PUBLIC HEALTH DIVISION
Drinking Water Services

**Re: Scenic View Drive Pump Station (PR#156-2022)
Rockaway Beach Water District (PWS ID# [00708](#))
Conditional Approval**

Scenic View Drive Pump Station for Rockaway Beach Water District (00708)
Conditional Approval – PR #156-2022

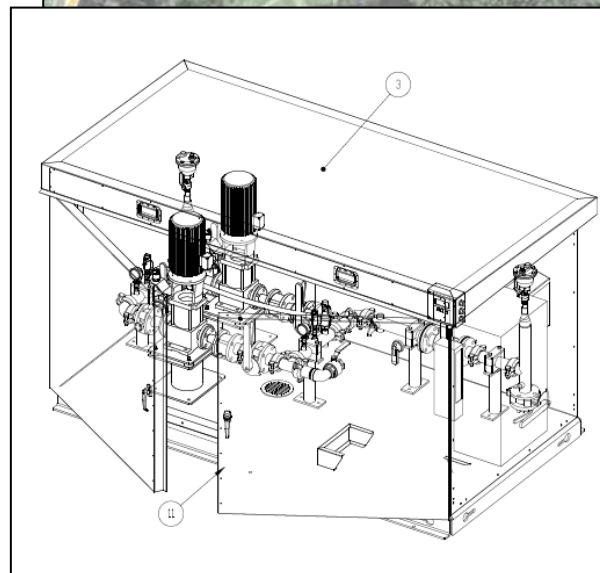
1. New facilities are disinfected and tested per the latest AWWA standards and [OAR 333-061-0050\(10\)](#).
2. As the pump station draws water from a water main, should suction pressures be less than 20 psi in the supplying water main upon construction, an explanation as to the severity of the low-pressure conditions and plans to mitigate low pressure in the main shall be submitted prior to Final Approval.
